ADDENDUM NO. 2

POLYTECH HIGH SCHOOL
RENOVATIONS AND ADDITIONS
BID PACKAGE 'A'

This addendum is hereby made part of the Project Manual and Drawings dated 9 July 2012.

CSK053

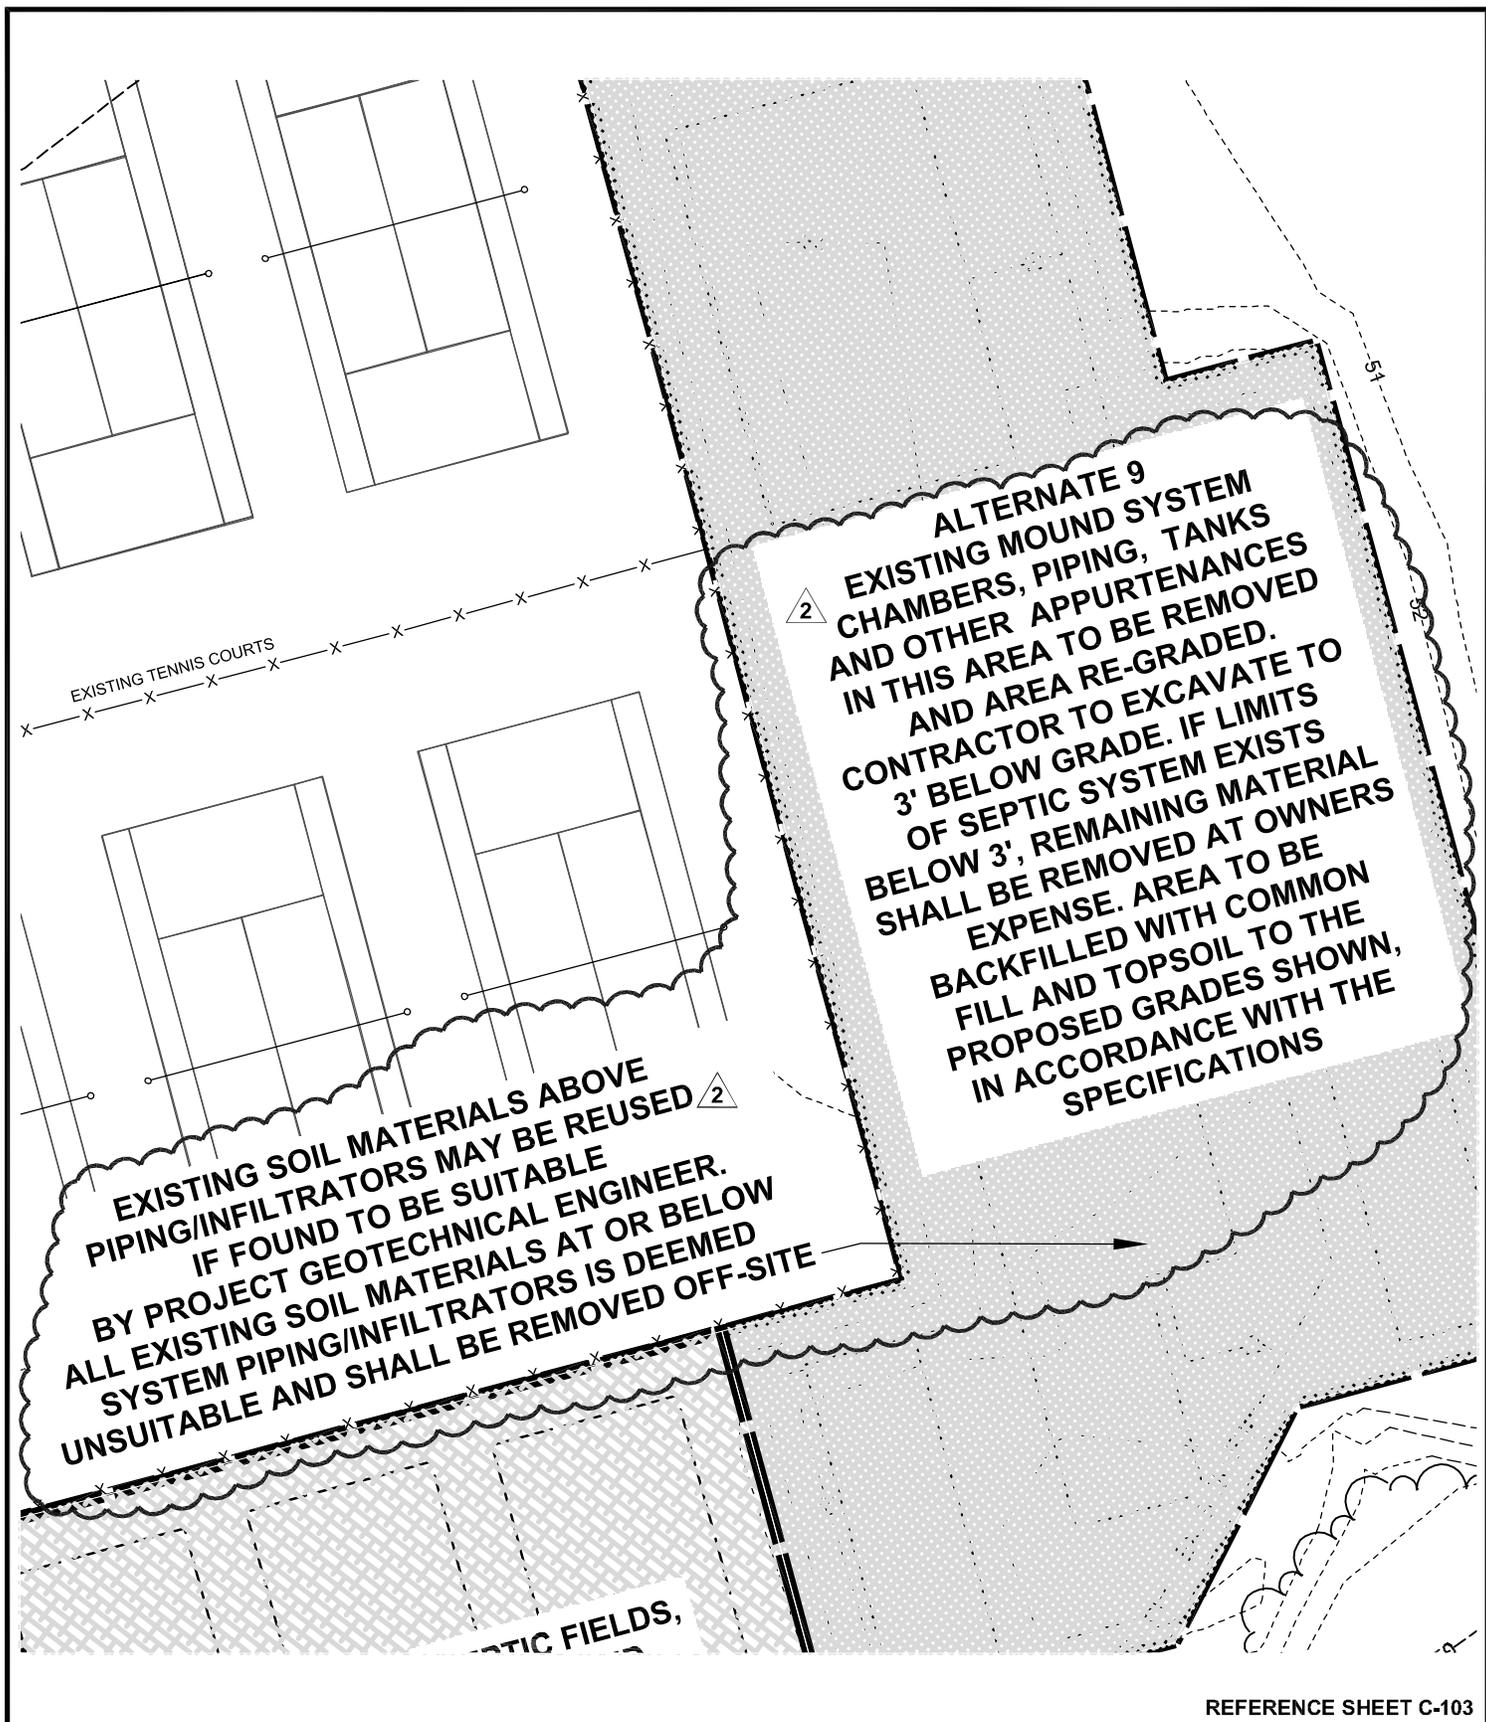
- A. **C-102 Demolition Plan** - Drawing revised as indicated on sketches CSK039, CSK040, CSK041, and CSK042 and included with this addendum.
- B. **C-103 Demolition Plan** - Drawing revised as indicated on sketches CSK043, CSK044, CSK052, CSK053, and CSK054 and included with this addendum.

CSK055

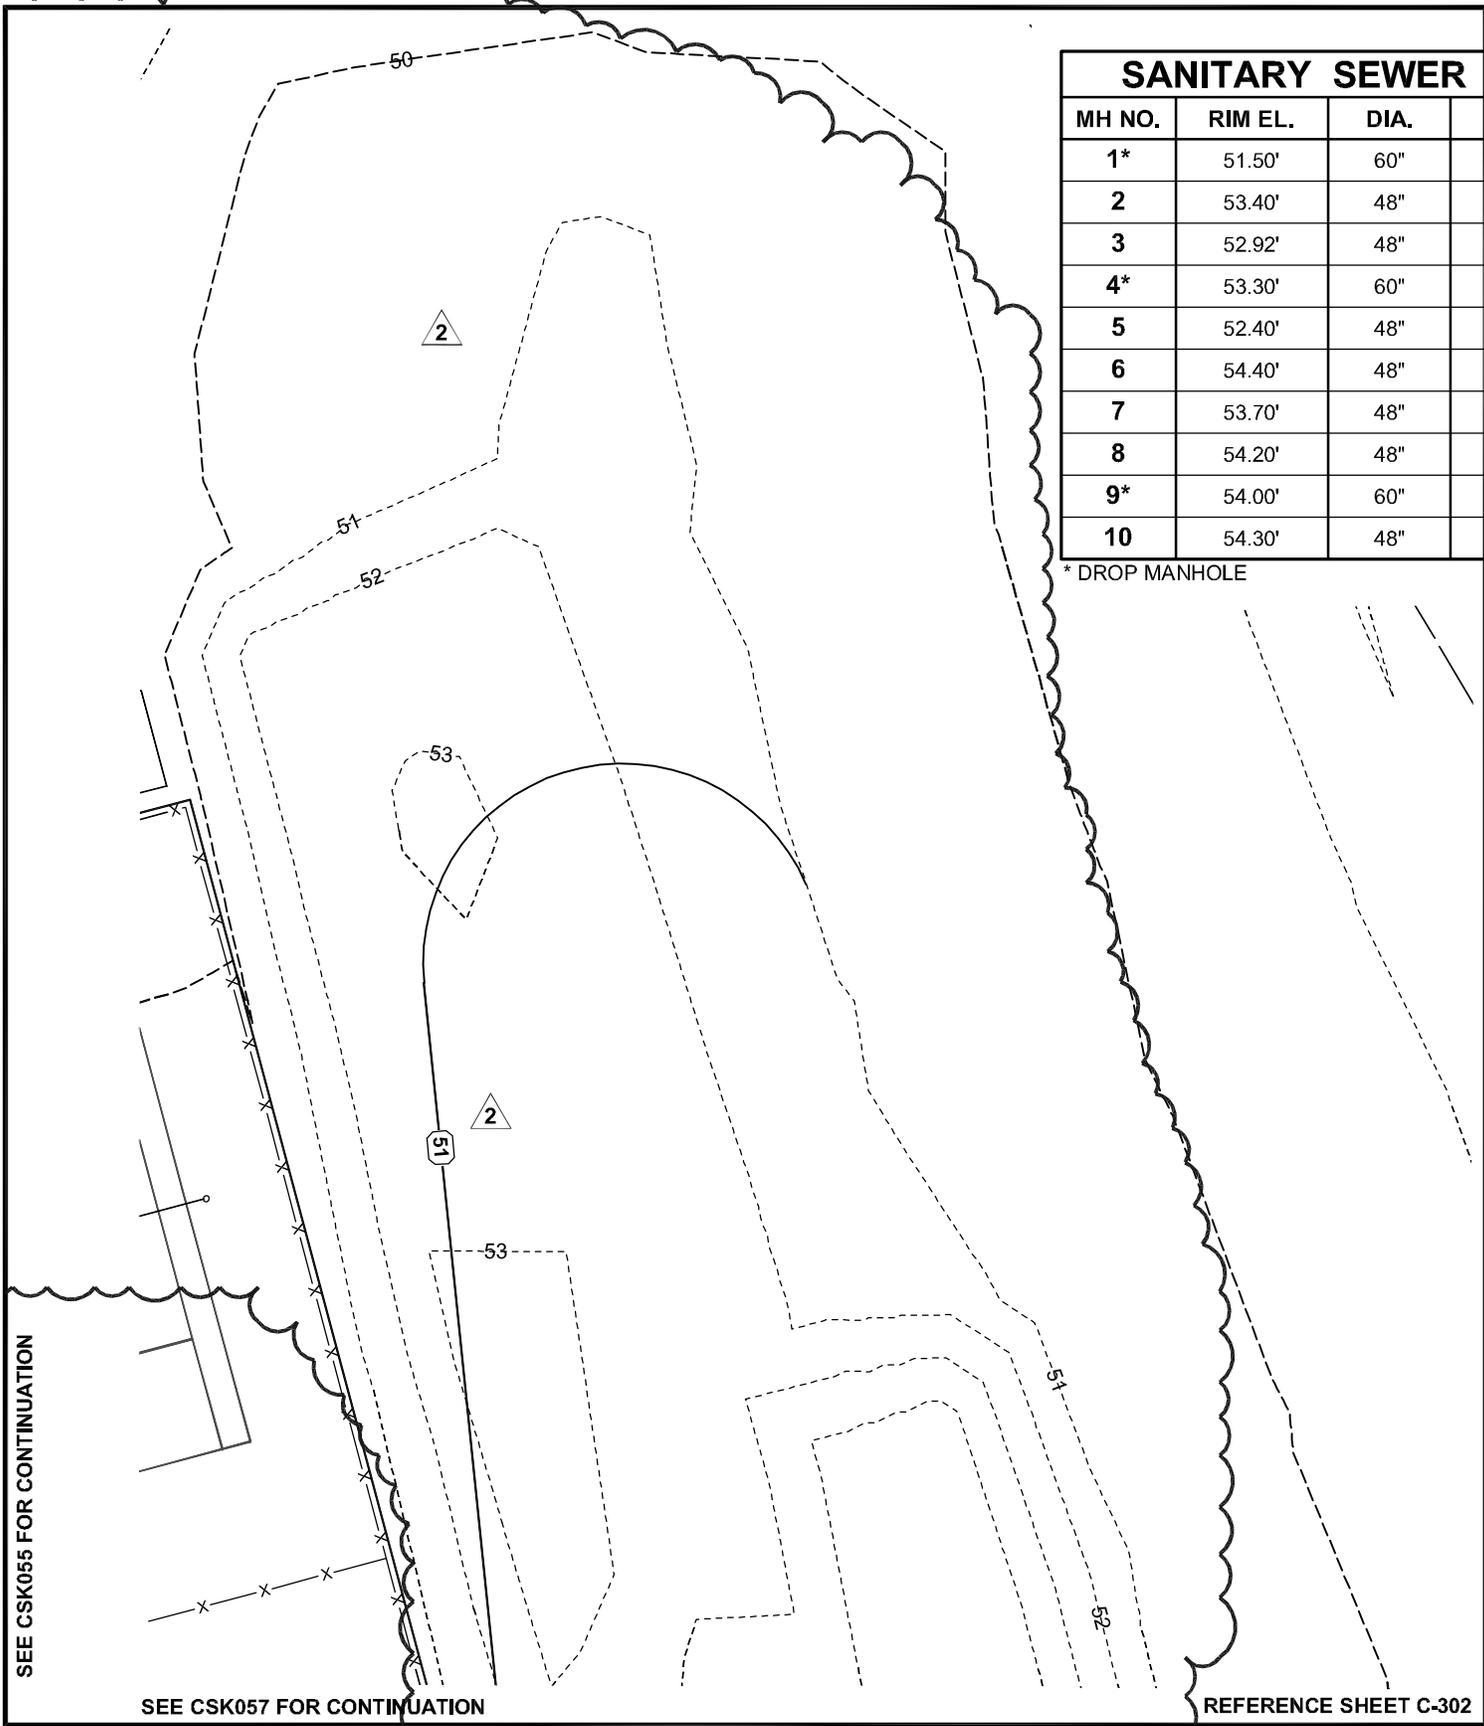
- E. **C-302 Utility Plan** - Drawing revised as indicated on sketches CSK050, CSK051, CSK055, CSK056, and CSK057 and included with this addendum.
- F. **C-303 West Side Pump Station Plans, Sections and Notes** - Drawing revised as indicated on sketch CSK047 and included with this addendum.

PUMP STATION ELECTRICAL SITE PLAN

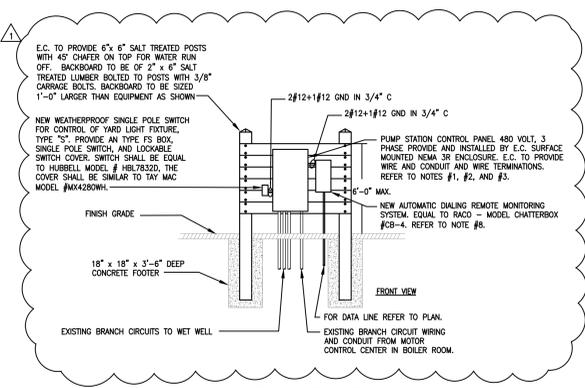
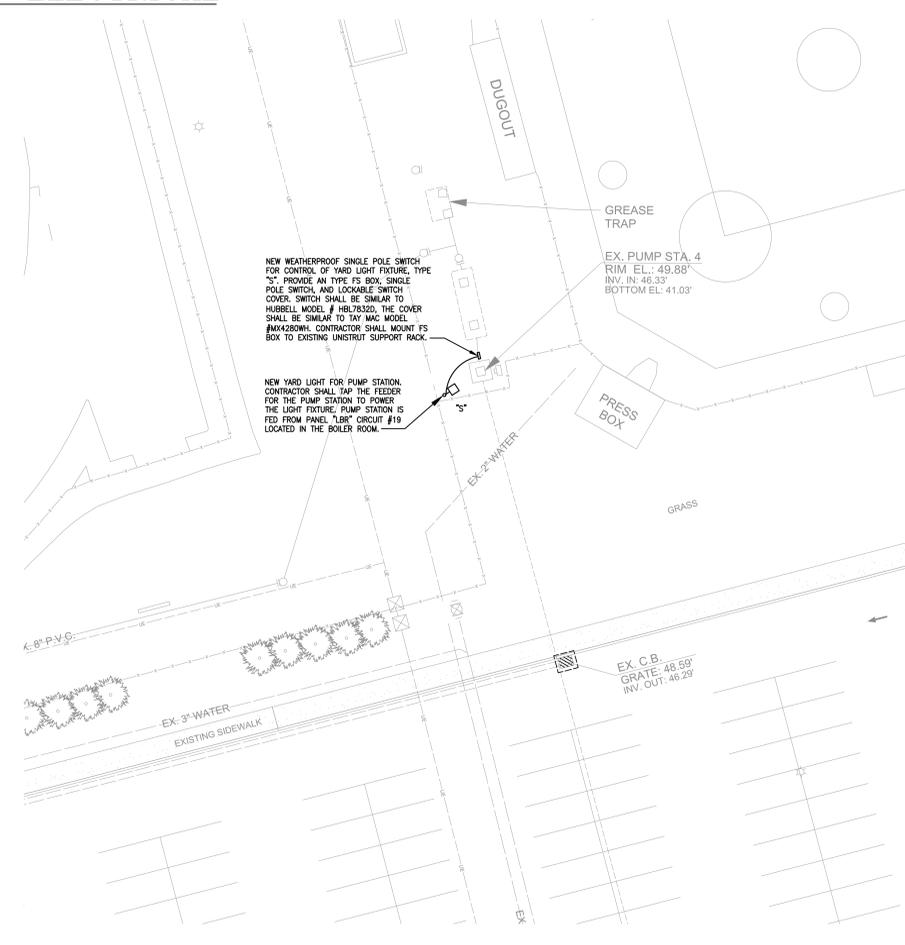
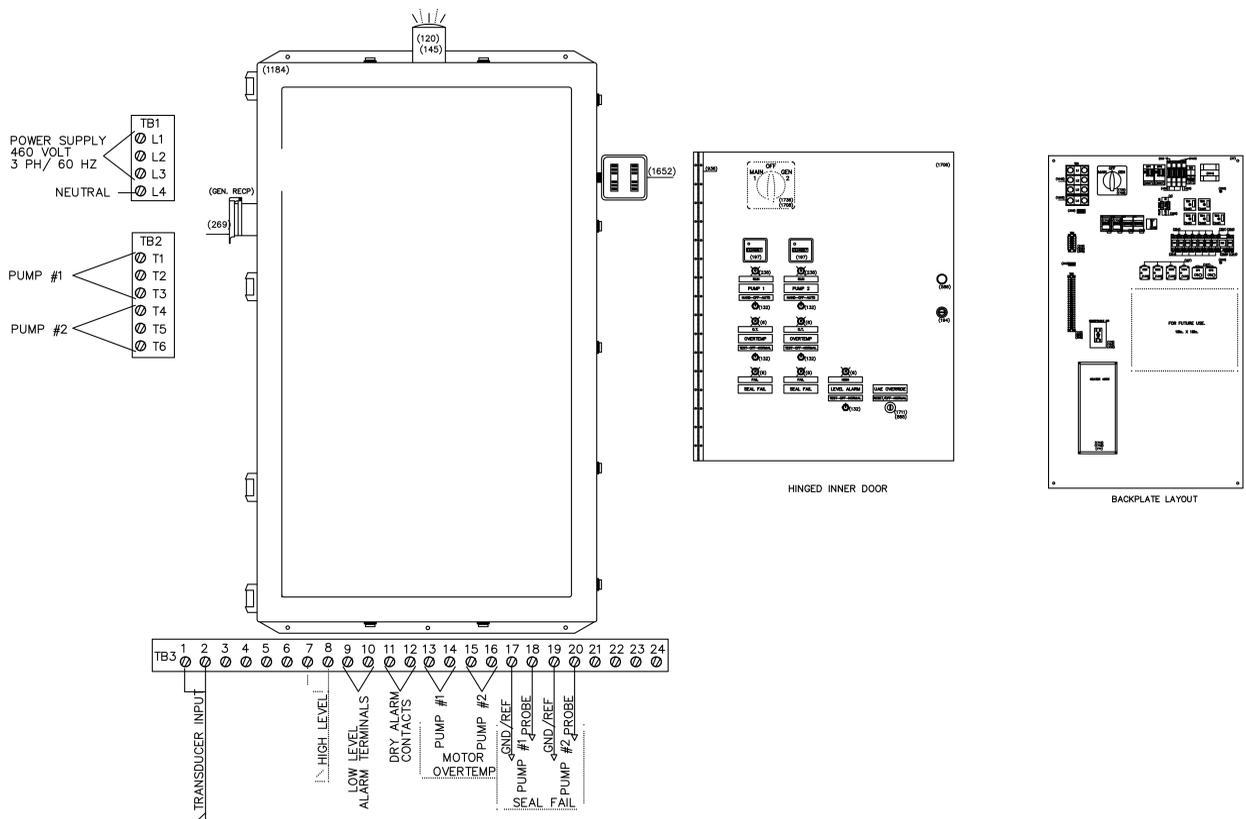
- I. **E-302 Pump Station Electrical Site Plan** – DELETE drawing E-302 in its entirety and INSERT revised drawing E-302, annotated addendum no.2, with latest revision date of 3 Aug 12.

1. Dwg E-302 shows 2#8 + 1#10 GND in 1" conduit and (2) 1" conduit spares between the East Pump Station and the existing building. General Note 3 states "Contractor shall reconnect existing feeder conductors and conduit to the new control panel and pumps." The panel detail shows the existing conduits and conductors. Are new conduits and conductors required or do we use the existing conduits and conductors? If new conductors are required, where does the contractor make the connection in the building?
2. Should the 9 - 4" conduits that run to the new transformer pad be in-cased in concrete?

1. Refer to Addendum #2.
2. The (9) 4" conduits should be incased in concrete only ay road locations.
